CONSTRUCTION SUMMARY

Lindsay 2017 Developments Inc. / Sugarwood

Lot/Unit: 27 Phase/Building: 1 Model/Floor Plan: Buckhorn Lake (3704) Elev B 4Bed 2.5Bath

SCHEDULE "B-1"
Floor Plan

Sketch #1

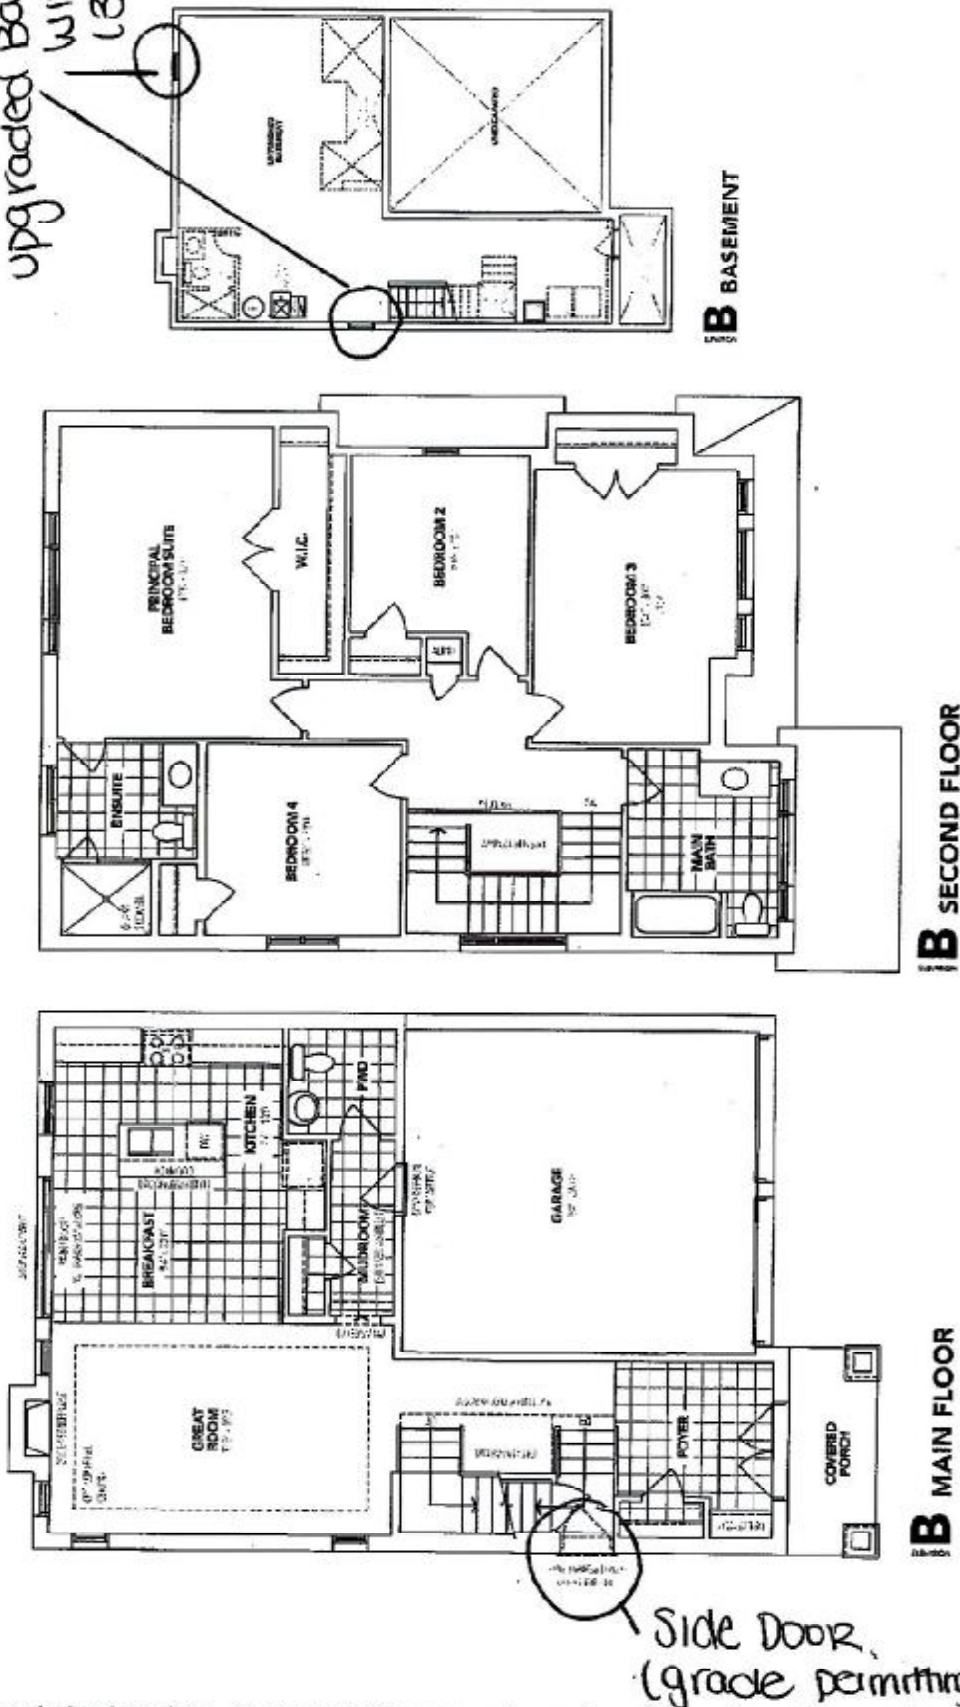
Inv.5776	1 - To supply and install the optional side door to the main floor as per plan.. see sketch #1 for details	
Line 73733	Note:	
31Aug22 / 1Sep22		
Inv.5776	2 - To supply and install upgraded basment windows, sized 36x24" in lieu of the standard size.. see sketch #1 for details	
Line 73734	Note: IF UNABLE TO ACCOMODATE, THE PURCHASER WILL BE CREDITED ON CLOSING.	
31Aug22 / 1Sep22

upgraded Basement
windows
(36" x 24")
